RE: 61 Ann Street, Dundas (DN/B-24:11) - Committee of Adjustment April 9, 2024 Agenda

DN/B-24:11

**Re: Application for Consent/Land Severance, File No. DN/B-24:11
By Agent Y. T. Wang on behalf of Owner J. Li for 61 Ann Street, Dundas.**

PRINT TITLE: **GRADING & SERVICING PLAN**

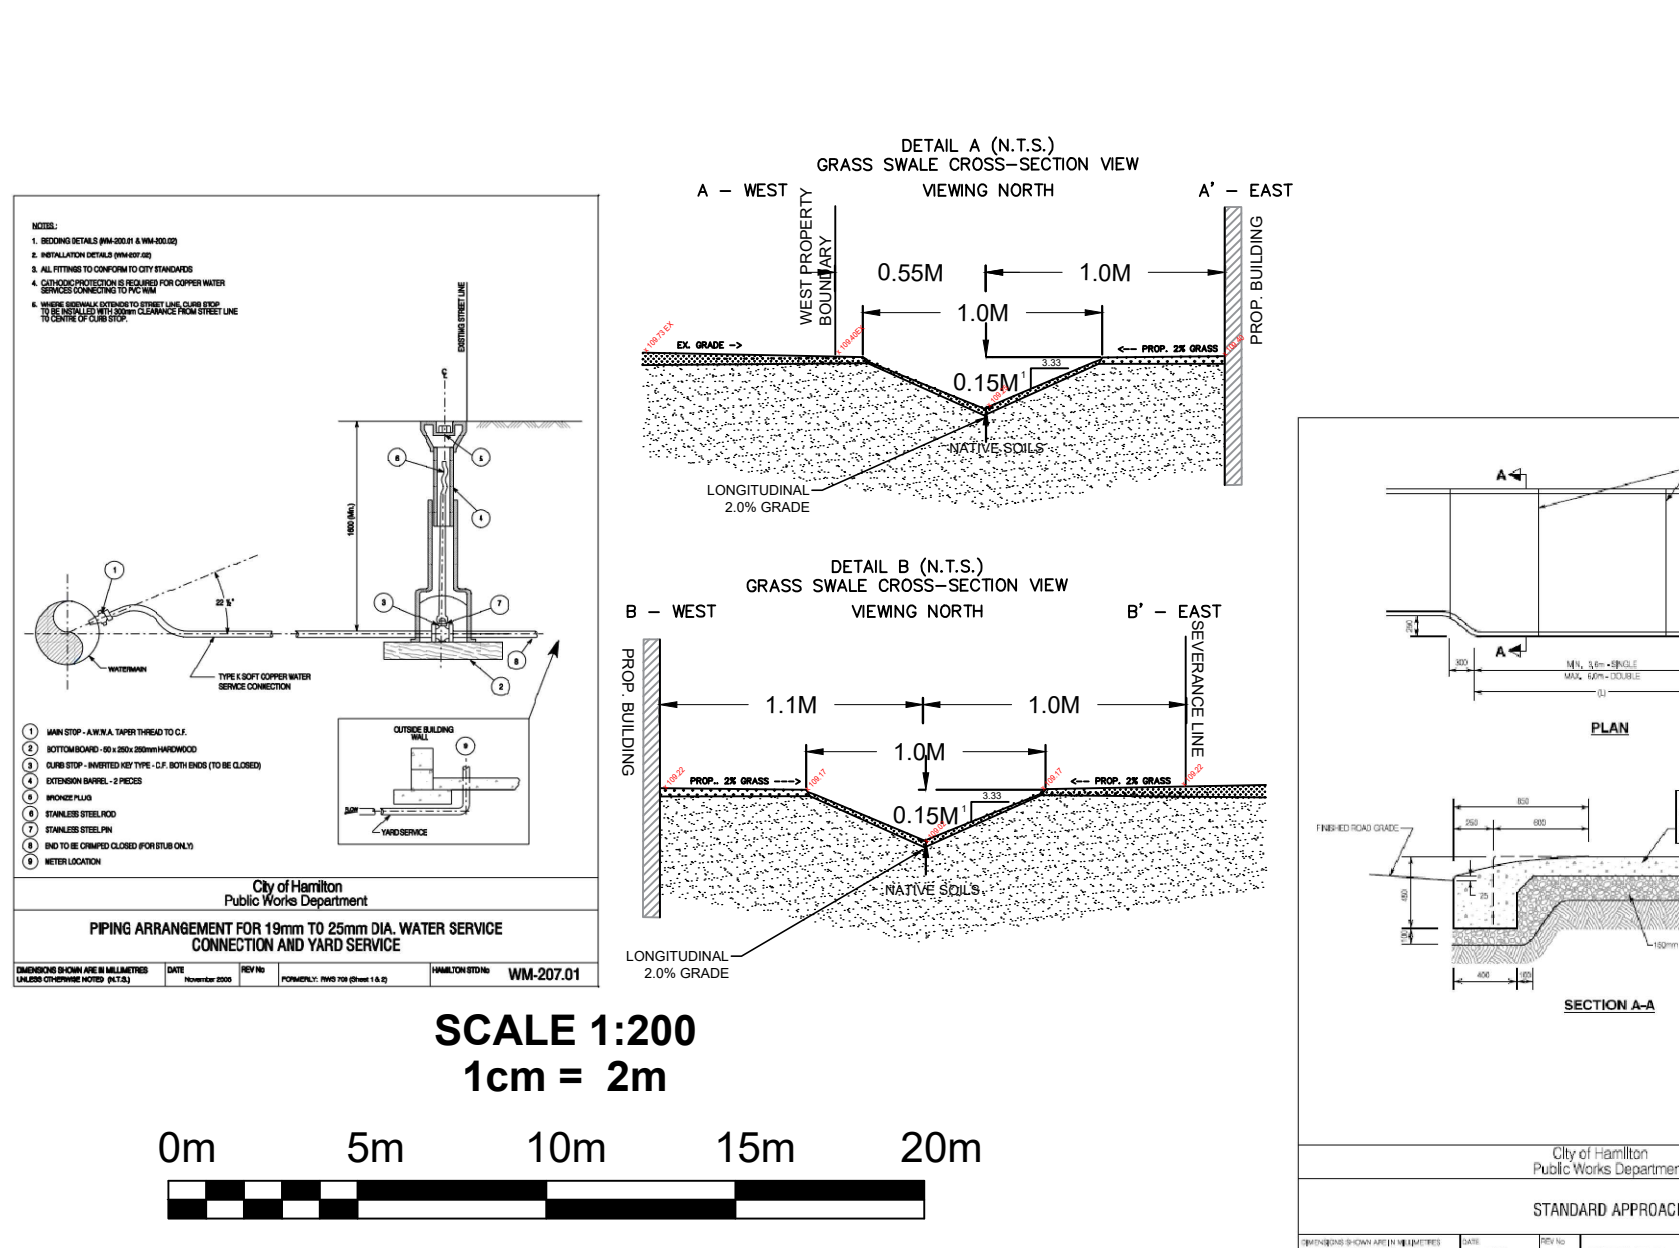
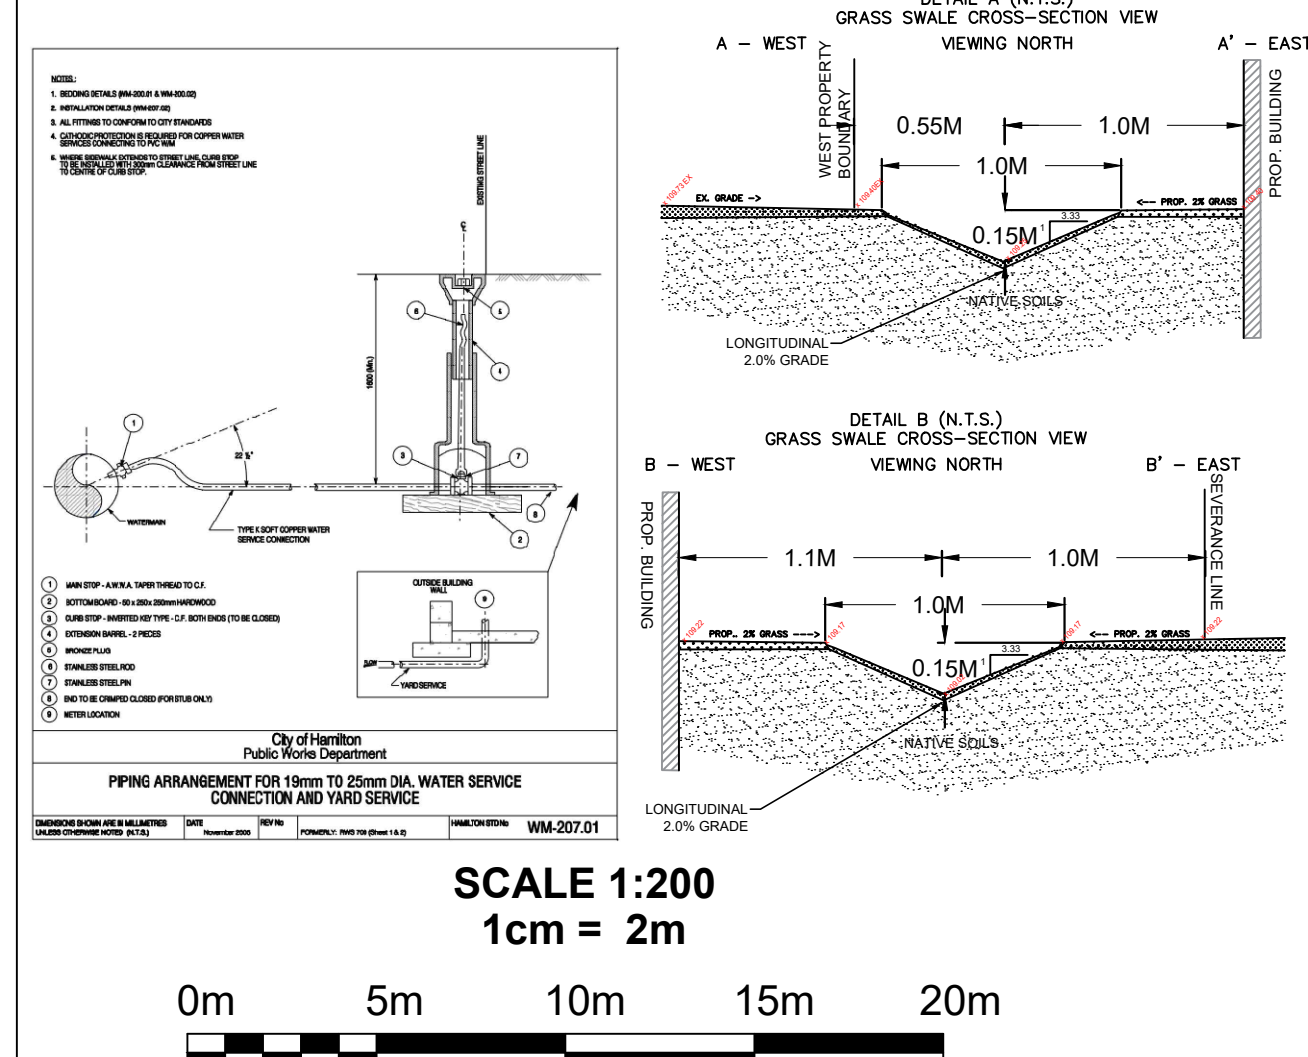
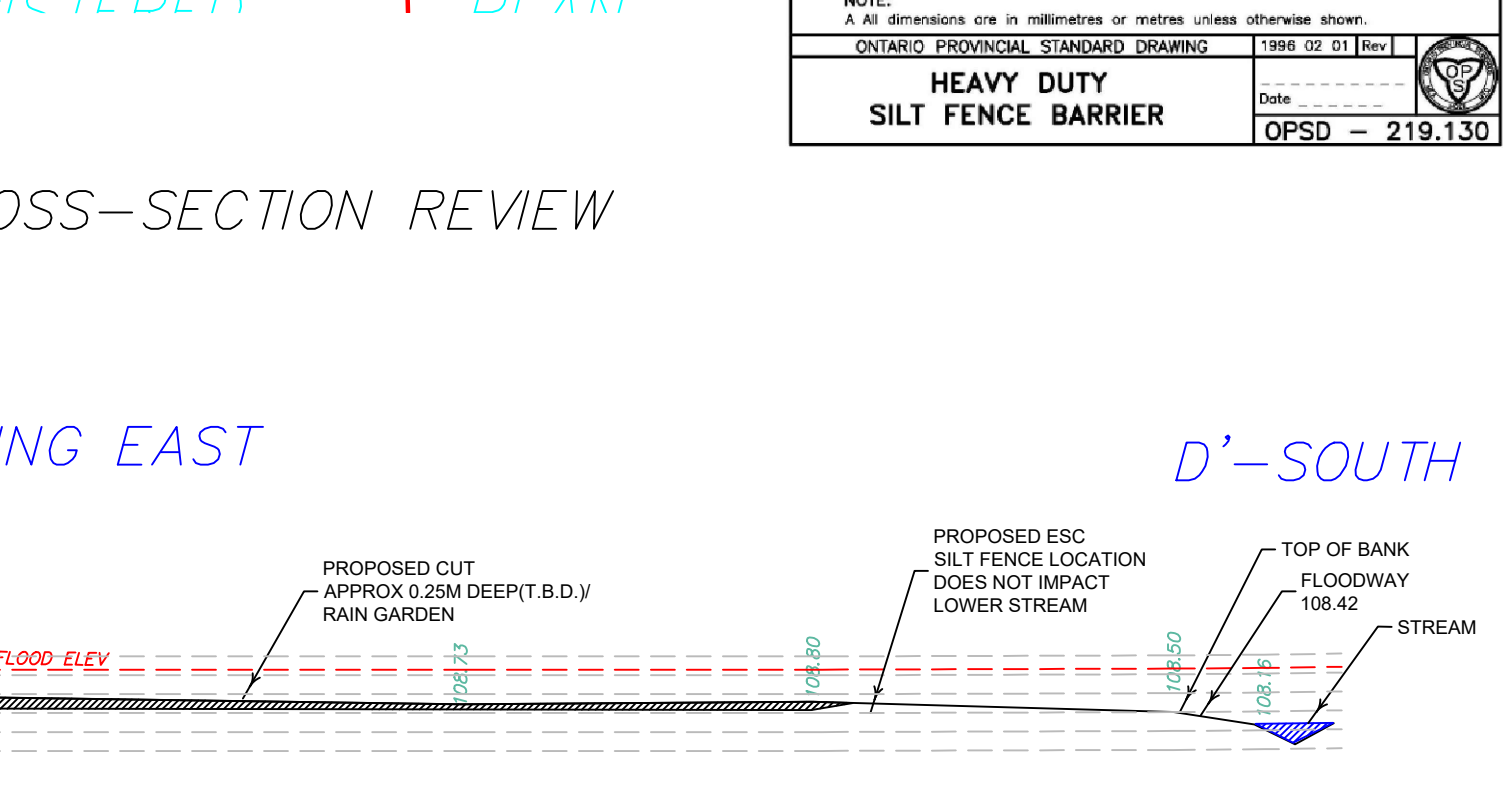
According to HCA floodplain mapping, the floodway (100-year storm) elevation is 108.42 m and the (regulatory) Regional storm is 109.65 m in the vicinity of the existing house. The Grading and Servicing Plan (dated December 13, 2023) labels the regulatory floodplain limit, but does not show the 100-year flood limit. To demonstrate that there is sufficient developable area on the proposed new lot, a detailed topographic survey, prepared by a qualified professional Engineer or Ontario Land Surveyor, should demonstrate that the house and all grading (e.g. rain garden) are outside of the 100-year floodplain (108.42 m). Therefore, the HCA requests that the plan be revised to show the limit of the 100-year floodplain (floodway) prior to approval of the consent application.

- Demonstrate that all development and site alteration are outside of the floodway.
- Floor plans and elevation drawings will be required to confirm that all openings in the house are above the Regional flood elevation and that electrical and mechanical equipment provide a 30cm freeboard from the Regional flood elevation.

- Demonstrate that hydrostatic pressure has no negative impact on the house foundation in case of the Regional storm event.
- If the rain garden is proposed, the applicant will need to provide satisfactory grading and section drawings supported by volumetric calculations of the balanced cut and fill. In addition, the applicant must demonstrate whether a relevant cut area is available in the flood fringe within the same section south of the channel, and that safe access to the potential cut area is possible for the equipment and machinery required to excavate the calculated cut volume on the opposite bank.

The PPS generally directs development to areas outside of natural hazard limits. As noted above, no development or site alteration are permitted within the floodway. Therefore, a revised grading plan is required prior to approval of the consent application to demonstrate that all proposed development and site alteration (house and rain garden) are located outside of the floodway.

Please receive the attached minor revision for site grading plan. This updated drawing clearly shows the 100 year floodway as requested in the HCA comments, with elevation at 108.42m. This updated drawing is minor adjustments in nature and generally the same as previous.

We believe that this is general fulfillment of HCA requirements, and that in concept and principal, we have not encroached into the floodway (108.42), and that all buildings are above 109.95 (30m freeboard above the regulatory floodplain elevation of 109.65).
